Access Compliance Report

Public Rights-of-Way

(Curb Ramps)

Intersection ID: 3612	Main Street: BRIDLE_RIDGE_LN	Cross Street: FURLONG_TL	Location: NE
ADA ID: 57095A29CA24	Ramp Type: Perp	Initial Pass/Fail: Fail	Overall Compliance: No
Severity Score: 8.75			
Codes/Mitigation Info/Possible Solution		Field Measurements/Component Compliance

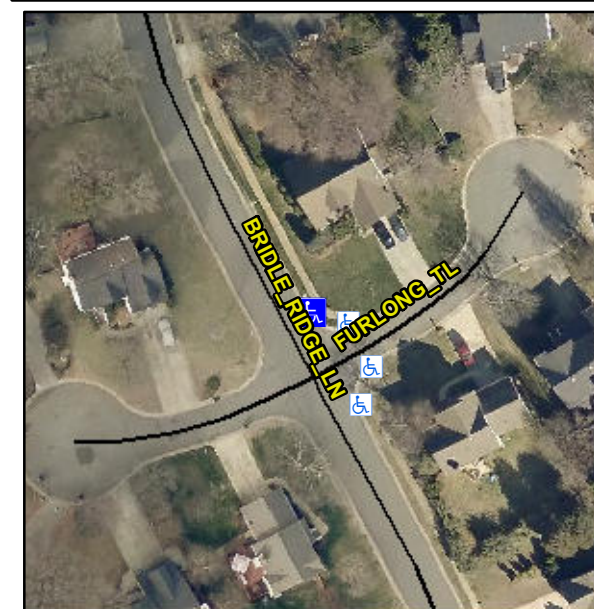
Not Found, R304.5.1

Compliance	Description	Data	Compliance	Description	Data
N/A	Ramp Length (in)	51.0	Yes	Ramp Slope (%)	5.0
No	Ramp Width (in)	47.5	Yes	Ramp XSlope (%)	0.8
N/A	Flare Type LT	N/A	N/A	Flare Type RT	N/A
N/A	Flare Slope LT (%)	N/A	N/A	Flare Slope RT (%)	N/A
N/A	Flare Traversable LT?	N/A	N/A	Flare Traversable RT?	N/A
N/A	Landing Length (in)	N/A	N/A	DWS Provided?	N/A
N/A	Landing Width (in)	N/A	N/A	DWS Contrast?	N/A
N/A	Landing Slope (%)	N/A	N/A	DWS Length (in)	N/A
N/A	Landing X Slope (%)	N/A	N/A	DWS Full Width?	N/A
N/A	Landing Curb? (Y/N)	N/A	N/A	DWS Offset (in)	N/A
N/A	Shared Landing?	N/A			
N/A	Gutter Ponding?	N/A	N/A	Gutter Slope (%)	N/A
N/A	Gutter Lip Ht (in)	N/A	N/A	Gutter X Slope (%)	N/A
N/A	Painted X Walk1?	No	N/A	Painted X Walk2?	N/A
	X Walk 1 Direction	To W		X Walk 2 Direction	N/A
N/A	X Walk 1 Width (in)	N/A	N/A	X Walk 2 Width (in)	N/A
	X Walk 1 Slope (%)	4.0		X Walk 2 Slope (%)	N/A
	X Walk 1 X Slope (%)	0.7		X Walk 2 X Slope (%)	N/A

Remove & Replace Entire Ramp.
